BUILDING APPLICATION FORM

I hereby apply for permission to ~~ERECT~~ ALTER ~~CONVERT~~ ~~REINSTATE~~ Head Office Premises

at 107 Cuba Street (House No. and Street) for Totalisator Agency Board (Owner)

for Alterations to T.A.B. Head
Office Premises at Cuba Street
-Wellington-

FIRST FLOOR PLAN EXISTING

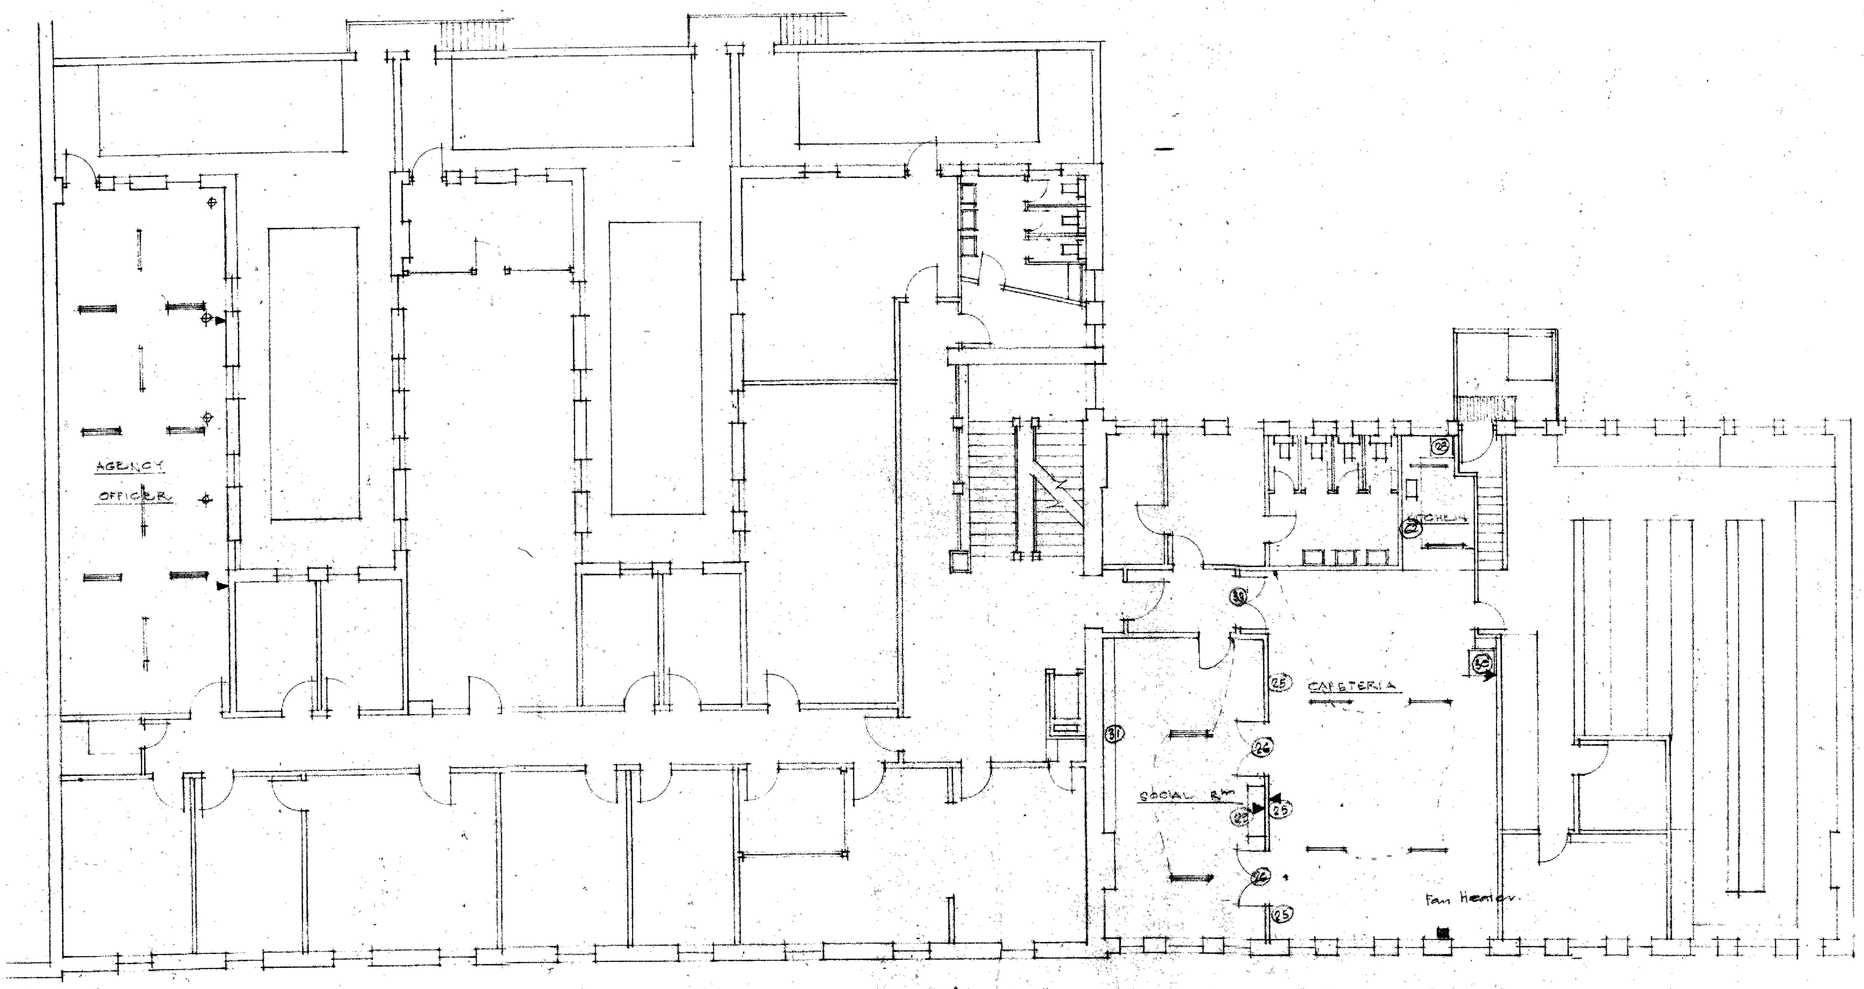
5.0 gal grease trap sited on flat roof, 1st floor & fire ventilated waste-masters not to be fixed
